**Addendum # 1**

**The North Carolina Department of Transportation  
Division of Highways, Division 13  
NCDOT McDowell County Maintenance/  
Bridge Maintenance Assembly Office  
3931 NC HWY 226S  
Marion, NC 28752  
SCO#: 14-11014-01A**

1 **LIGHTING - LOBBY 100**  
 SD E-1 SCALE: 1/8" = 1'-0"

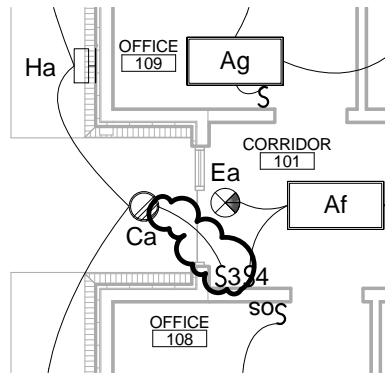
**Item E-1: Outdoor Light Switches:** Refer to attached supplemental drawing SD E-1 for revisions to E2.1 for additional light switches in Lobby 100 and Corridor 101.

2 **LIGHTING - CORRIDOR 101**  
 SD E-1 SCALE: 1/8" = 1'-0"
